SUBJECT: FCC Application for (FCC ID : 2AFWN-WA23FO012W0)

We, SOLUM CO., LTD. request to change for authorized product (FCC ID : 2AFWN-WA23FO012W0) for the following reason

Antenna photo	Antenna location photo

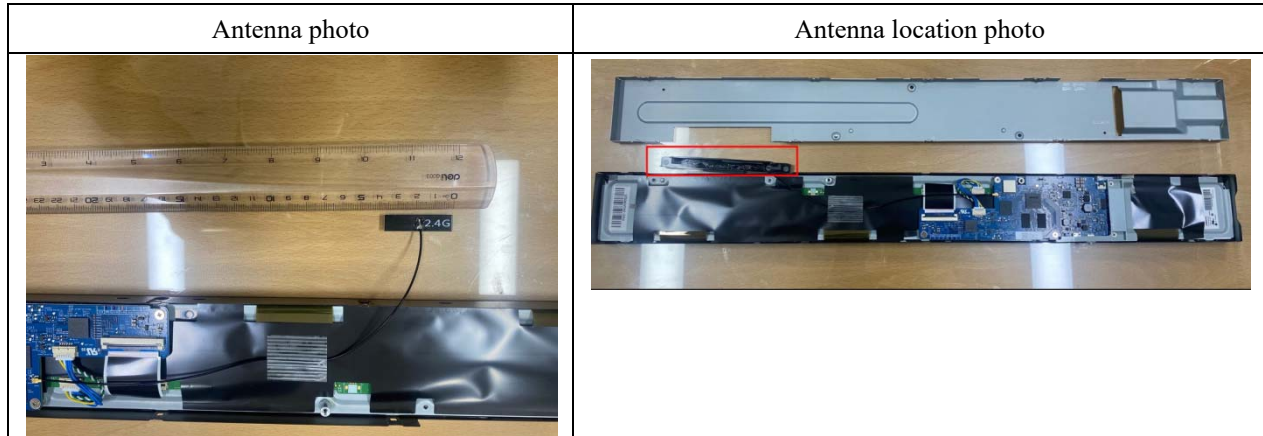
- Operational description Antenna specification add
- The absolute gain (2.50 dBi) of the antenna being changed does not exceed the absolute gain (3.62 dBi) of the antenna before the change.
